SHAIKH SUBDIVISION

APPLICATION NUMBER 16 DATE November 15, 2007

DETAIL SITE PLAN

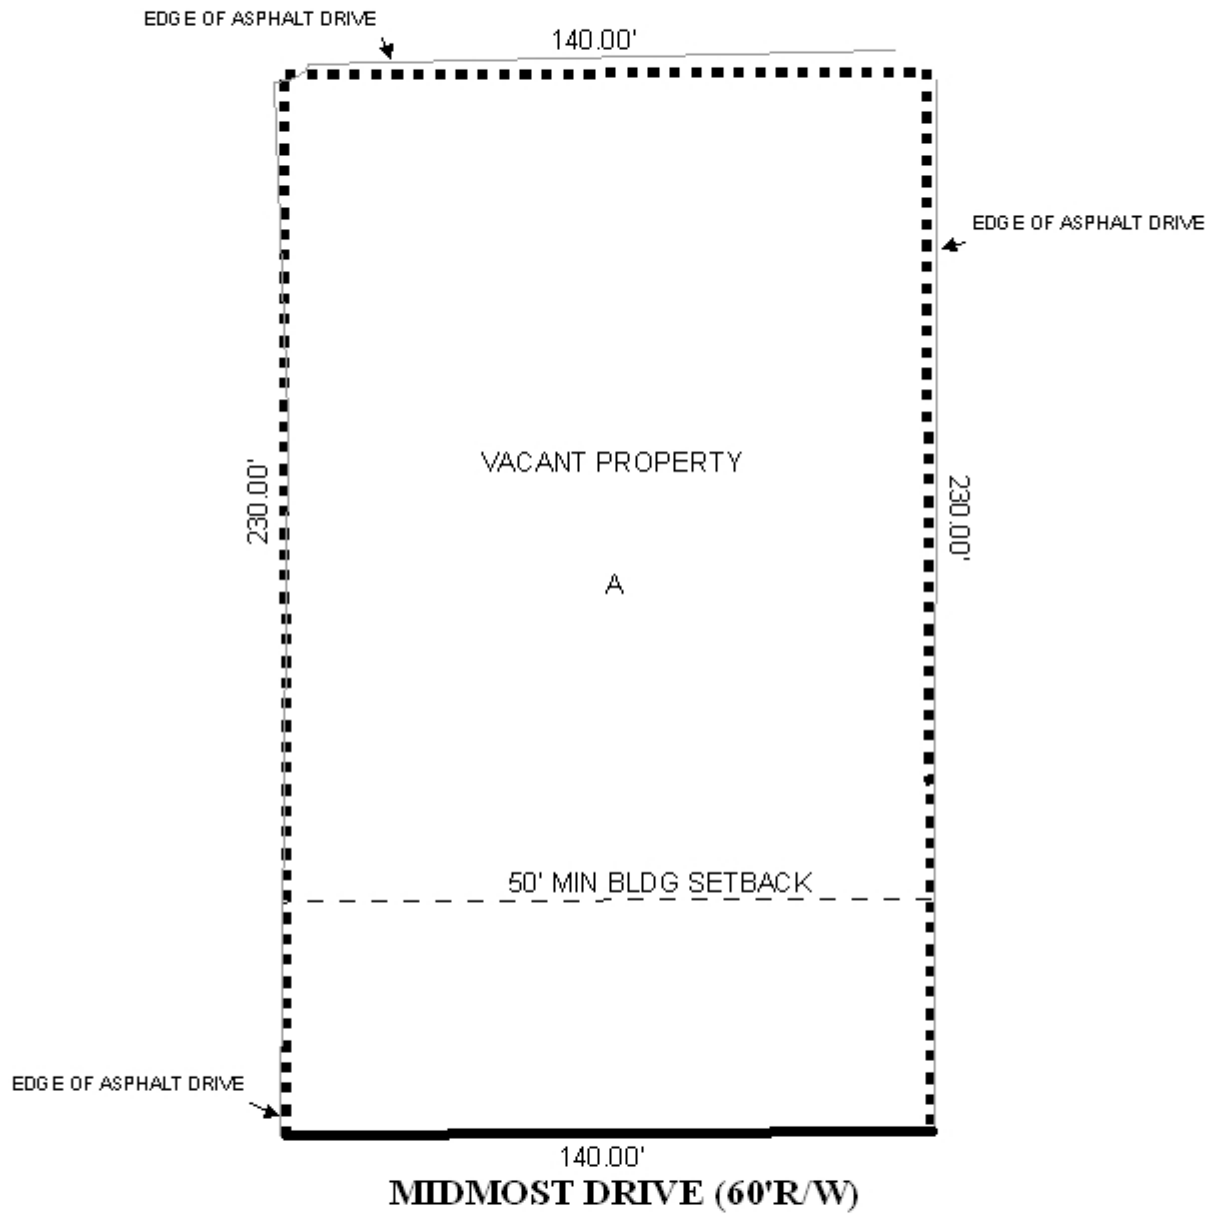
The proposed lot contains a portion of Lot 15, Downtown West, Unit Two; therefore, the plat should be revised to include the remainder of Lot 15 in the subdivision.

The site has approximately 140' of frontage along Midmost Drive; therefore, a note should be placed on the final plat stating that the site is limited to one curb cut, with the size, location and design to be approved by Traffic Engineering and conform to AASHTO standards.

- 1) revised plat including Lot 15 in the subdivision; and
- 2) postage and fees.
